JRPP NUMBER:	2011SYE067
DA NUMBER:	LDA2011/0303
LOCAL GOVERNMENT AREA:	City of Ryde
PROPOSED DEVELOPMENT:	Demolition of existing structures and construction of a seven storey mixed use development containing retail/commercial floor space at the Ground Floor Level; 97 residential apartments; and parking for 152 motor vehicles over three basement levels
STREET ADDRESS:	219 Blaxland Road, Ryde
APPLICANT:	Blaxland House Pty Ltd
NUMBER OF SUBMISSIONS:	One submission received
RECOMMENDATION	Approval, subject to Conditions at Attachment 1
REPORT BY:	Architectus Group Pty Ltd, Consultant Town Planners to City of Ryde Council

Assessment Report and Recommendation

Figure 8 Area of non-compliance with the maximum 18.5 metre height standard.

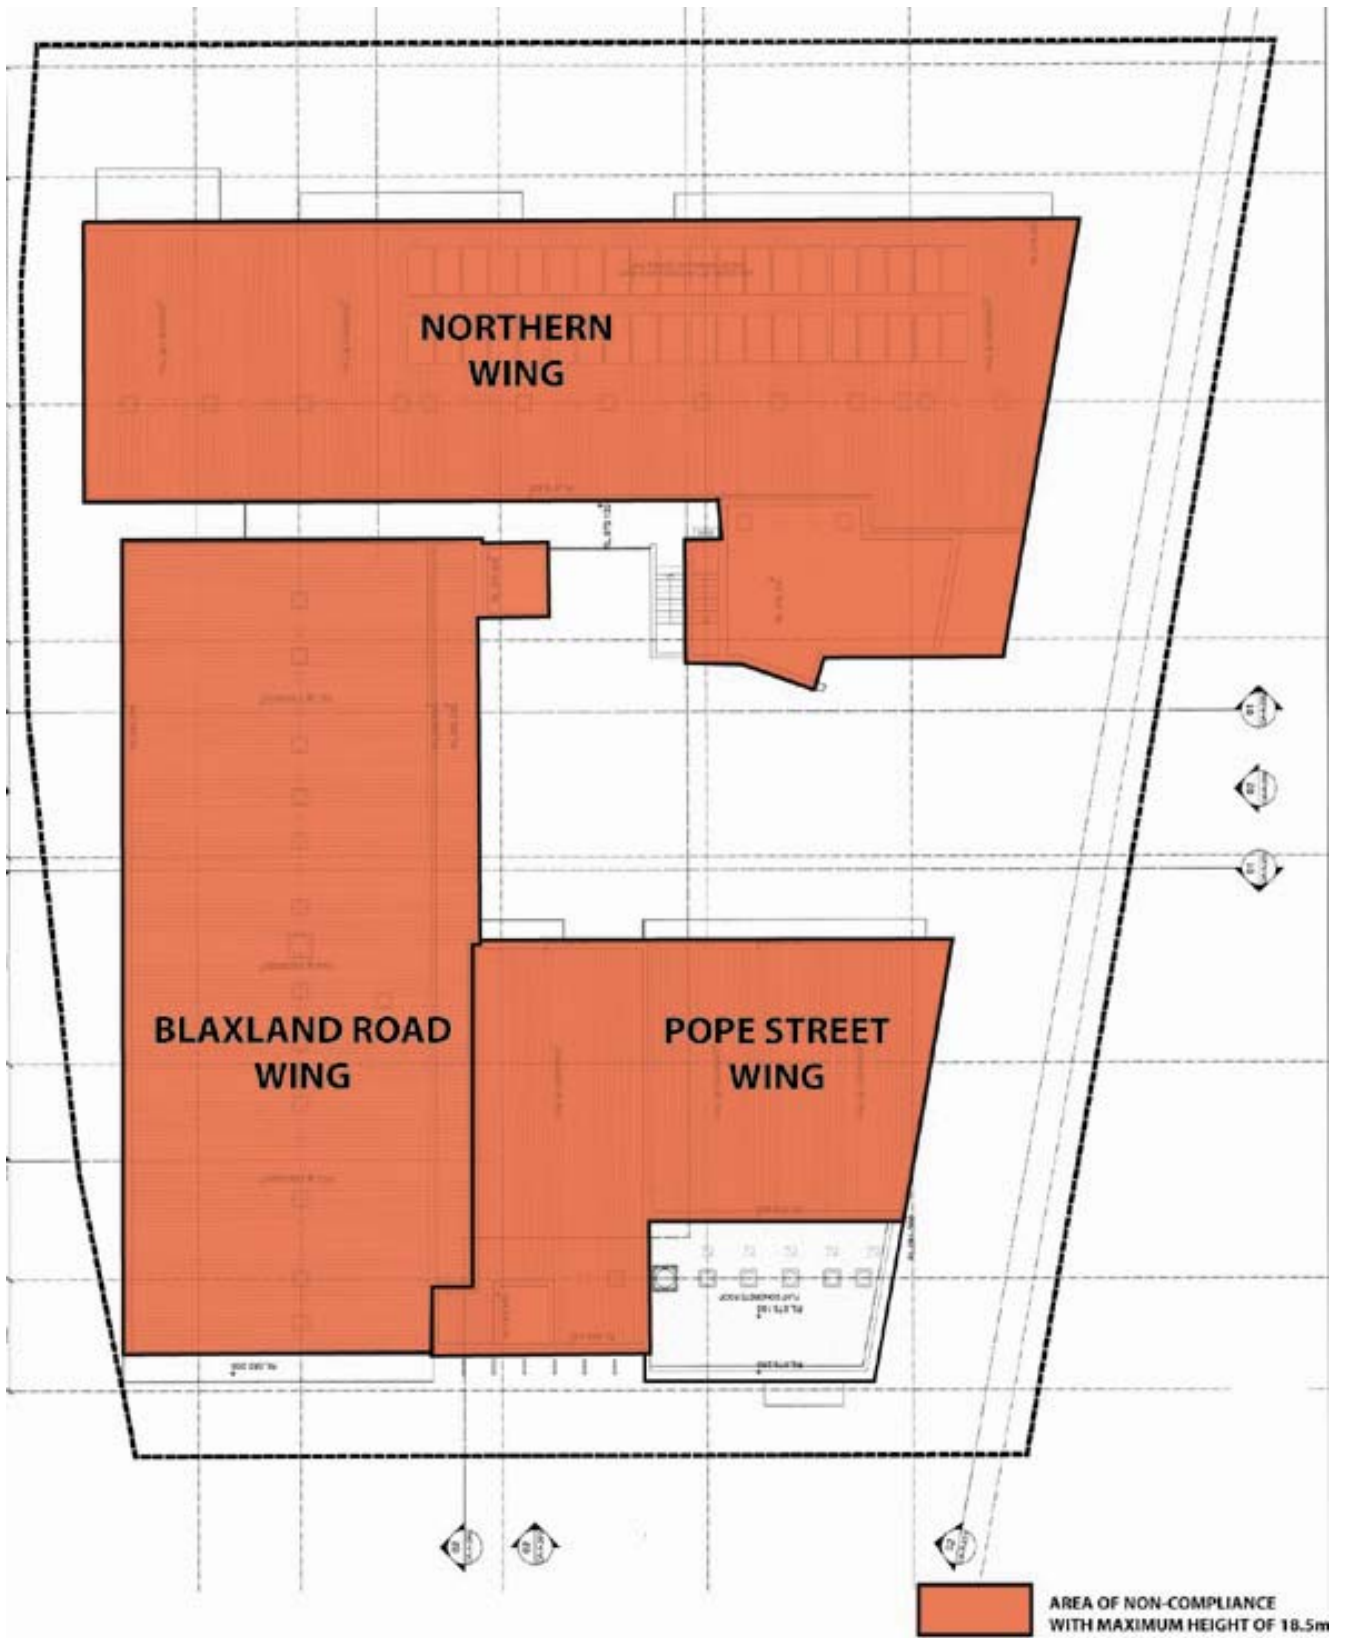
The proposed development exceeds the maximum height permitted under the Ryde LEP 2010 across the majority of the building, with the exception of the rooftop plant in the south-east corner of the Pope Street wing, which is at 18.5 metres in height. The area of non-compliance is illustrated at **Figure 8**, **Figure 9** and **Figure 10** below.

- Blaxland Road wing and western portion of Pope Street wing – 23.0 to 24.2 metres (including plant) and seven storeys.
- Pope Street wing (eastern portion only) – 18.5 to 20.4 metres (including plant) and six storeys.
- Northern wing – 18.9 to 19.8 metres (including plant) and six storeys.
